March 31, 2022

Scott M. Rybarczyk, PE  
Wendel  
Centerpointe Corporate Park  
375 Essjay Road, Suite 200  
Williamsville, NY 14221

**RE: REVIEW OF STAMP DISCHARGE TO OAK ORCHARD CREEK**

**DISCHARGE**  
**STA. D10+00 TO STA. D14+00**

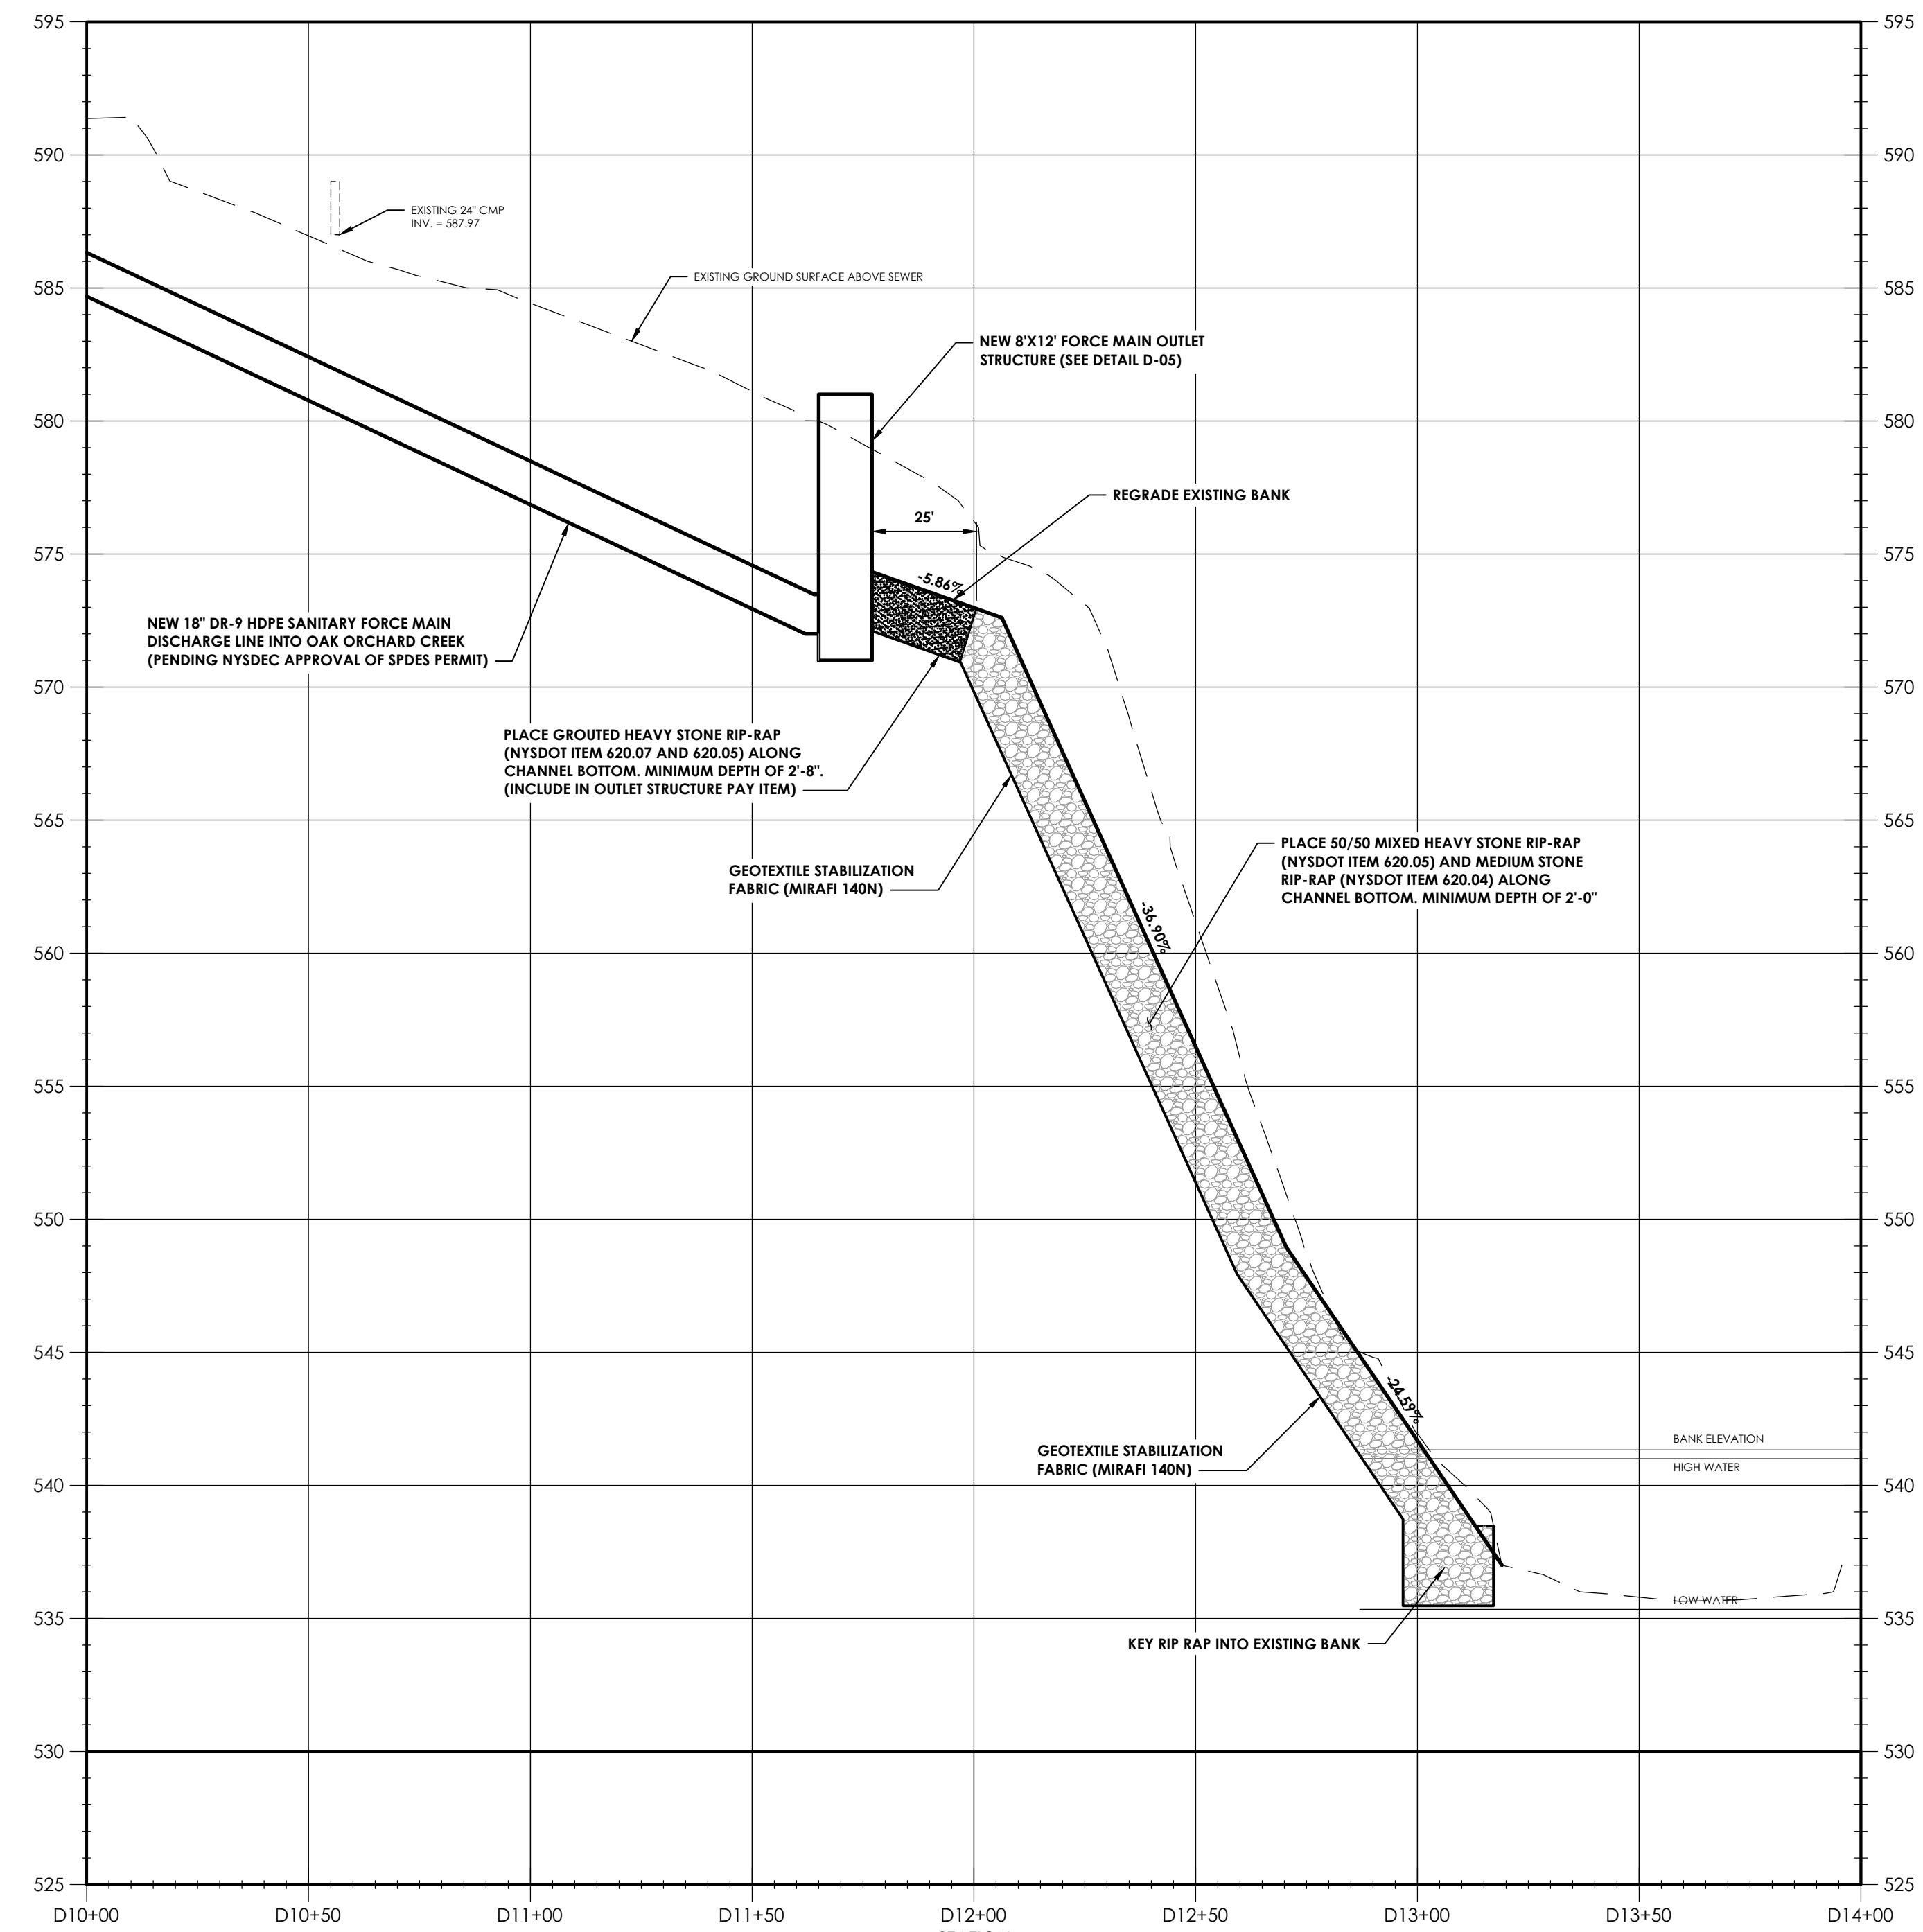
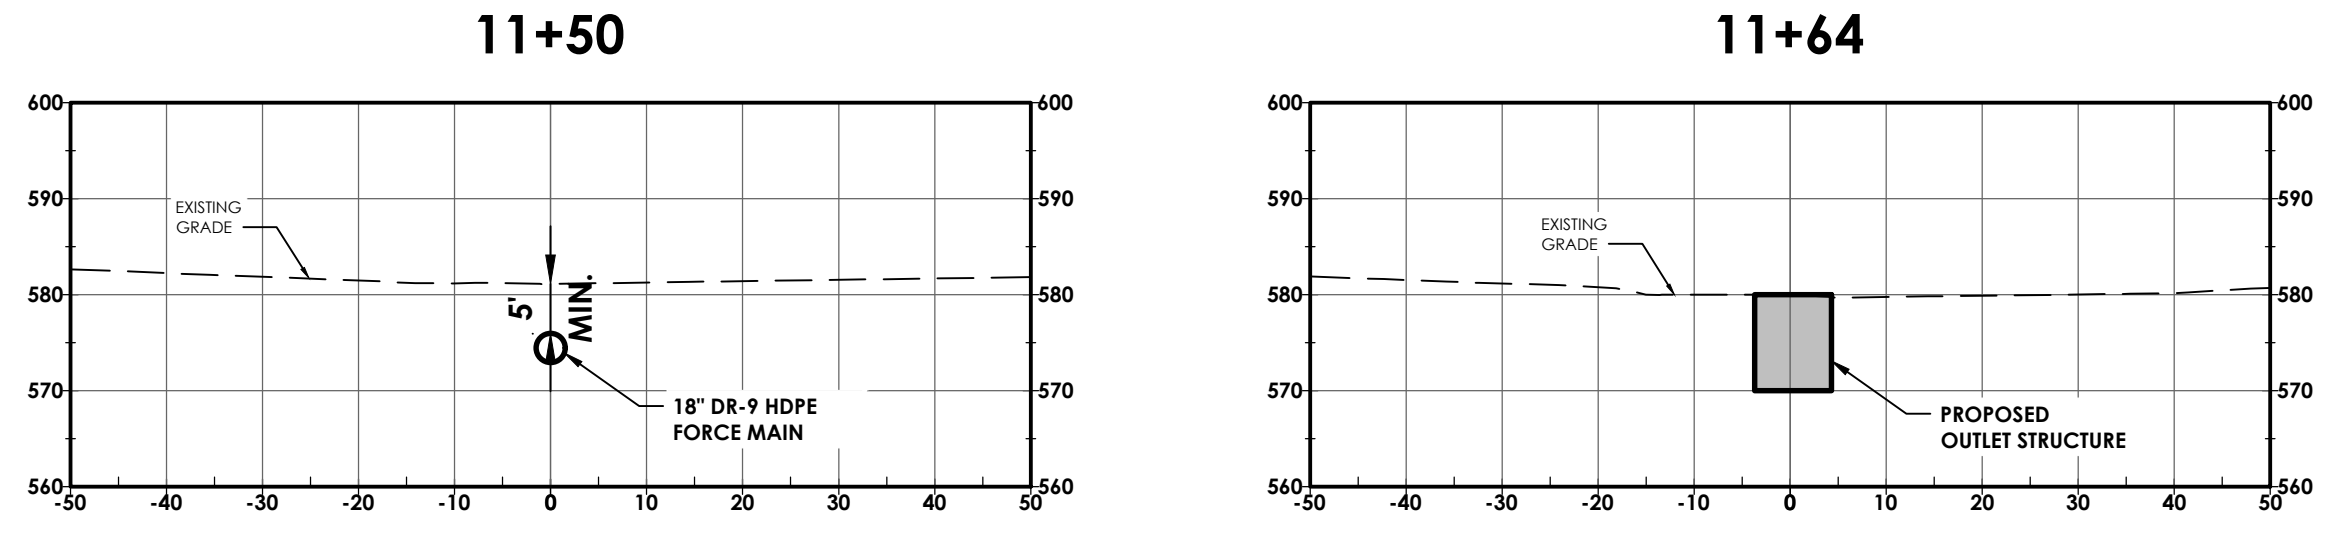
7. The outlet structure detail shown on design drawing FM D-05R is incomplete. It is difficult to determine the outlet shape directly upstream of the outlet protection outside of the structure. This is important as it will determine the flow characteristics exiting the outlet.

*Response: Cross sections just above the outlet structure have been provided. According to these cross sections, the grade is very consistent and does not indicate a defined drainage channel. We feel it is not necessary to extend the gravel rip-rap protection further up the hill.*

**OUTLET CHANNEL SECTION VIEWS**  
SCALE: 1/4" = 1'

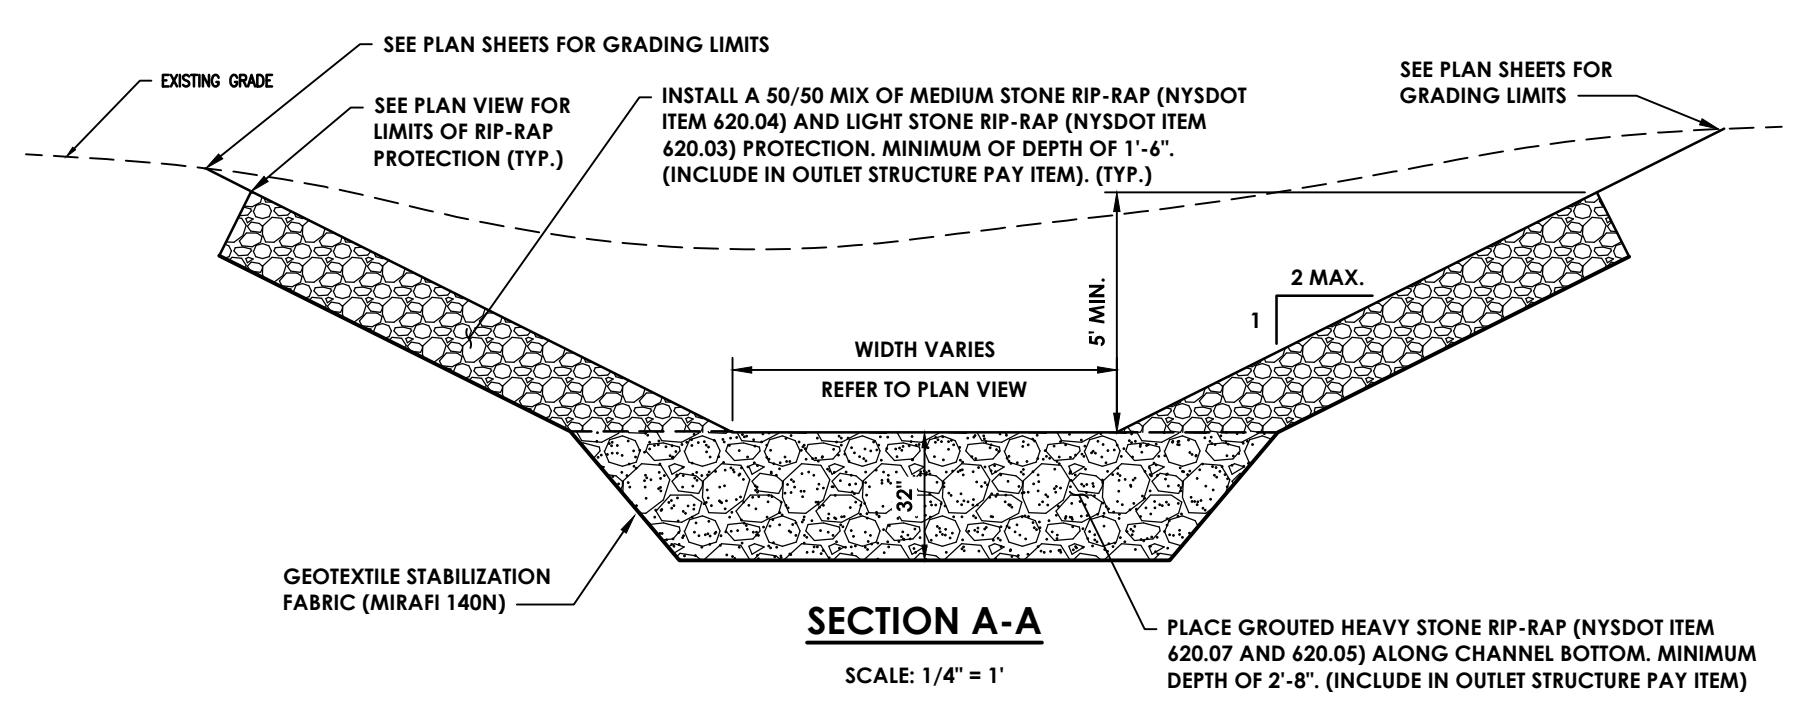
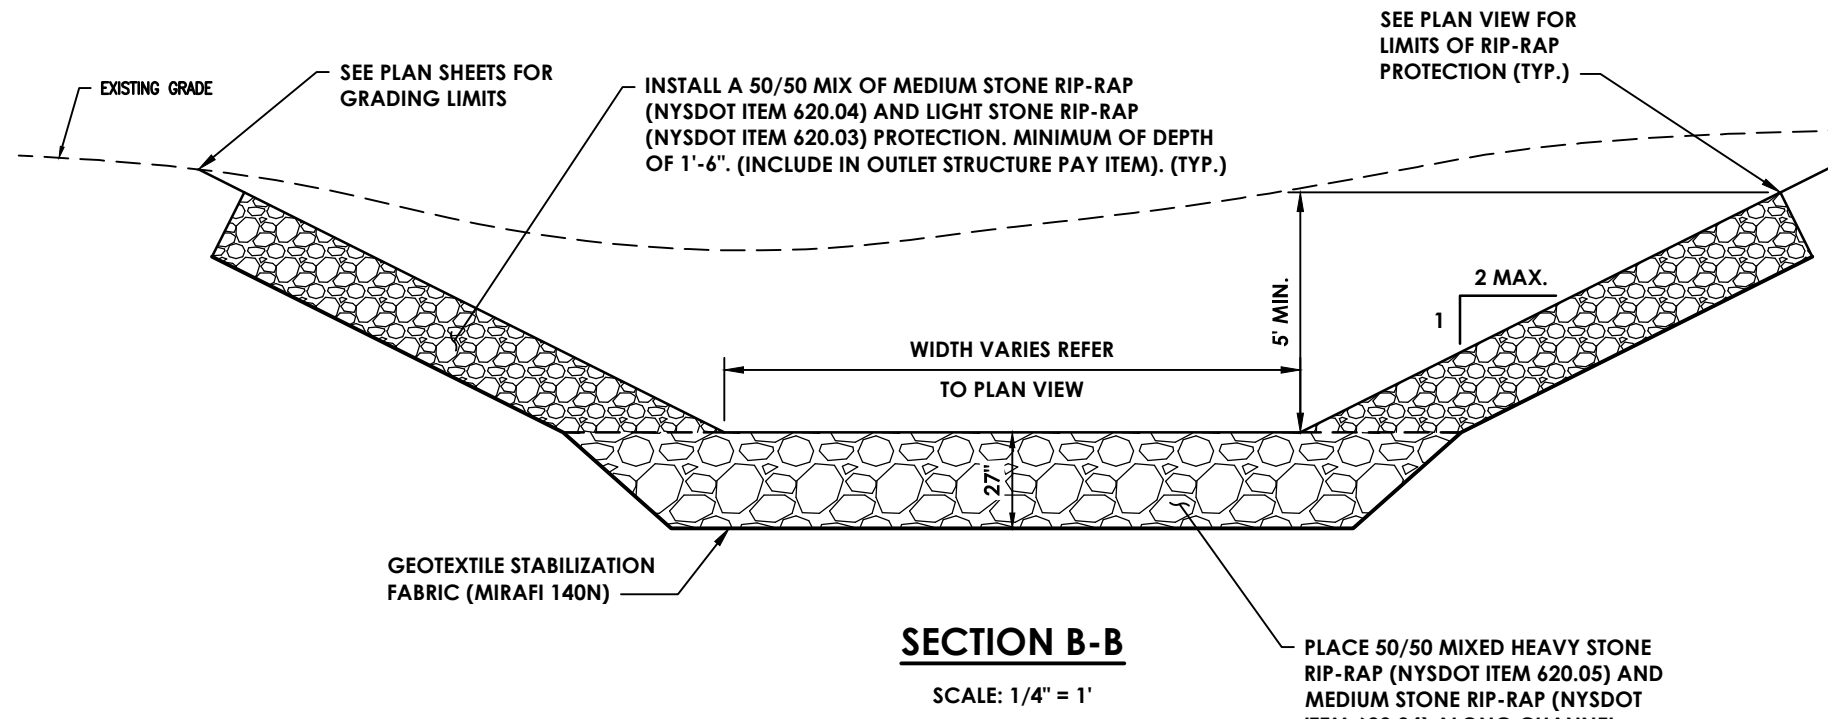
***Response: Noted – please see the responses below.***
5. It is our opinion that the outfall has not been adequately designed to avoid soil erosion. Specifically, the rip-rap section is too thin. On Page 3.28 of the NYS Standards and Specifications for Erosion and Sediment Control, it states that the minimum lining thickness shall be 1.5 times the maximum stone size. The maximum stone size for this project is heavy stone riprap with a diameter of 23” inches as per the NYS DOT Specification for Heavy Stone Riprap. This would lead to a minimum lining thickness of 34.5”. This is larger than the actual lining thickness of 24” or 32” shown on design drawings FM D-05R and FM S-61R (attached).

6. The lack of proper lining thickness can lead to loss of stone protection over time. Without stone protection, the outfall would likely erode discharging sediment to Oak Orchard Creek.

***Response: According to the NYS Department of Transportation Specifications Section 733-22, riprap calls for rectangular shaped stone for grouted rip rap sections. According***

*to Table 733-21B for stone filling sizes, the largest dimension (d) for a heavy stone filling, rectangular shaped stone is 15-inches. Furthermore, the channel from the outlet structure to Oak Orchard Creek was designed based on the Standard Specifications for Rock Outlet Protection from the NYS Standards and Specifications for Erosion and Sediment Control. The specifications on page 3.40 states; “The minimum thickness for the riprap layer shall be 1.5 times the maximum rock diameter for  $d_{50}$  of 15 inches or less; and 1.2 times the maximum stone size.” According to the table on page 3.40 for a  $d_{50}$  of 15 inches, the  $d_{max}$  is 22 inches, multiplying 22-inch  $d_{max}$  by 1.5 gives a minimum gravel blanket thickness of 33”. However, the table below the abovementioned paragraph on page 3.40 specifies a minimum blanket thickness of 32”. Because this section will be grouted, which will further bind and hold the riprap in place, a 32-inch grouted blanket has been specified.*

*For the lower section, a 50/50 mix of heavy stone filling and medium stone filling has been specified. The maximum stone size according to Table 733-21B of the NYS DOT Standard Specifications is 17-inches for medium stone fill, the maximum size for heavy stone fill is 23-inches. According to page 3.40 of the NYS Standards and Specifications for Erosion and Sediment Control specifies a blanket thickness of “1.2 time the maximum stone size for rip rap larger than 15 inches.” Therefore, the thickness of the blanket should be 27-inches. The design plans have been modified to reflect this change.*

*Response: Based on the above, we feel that the gravel banket has been adequately sized to protect the channel from erosion and sediment loss to Oak Orchard Creek.*
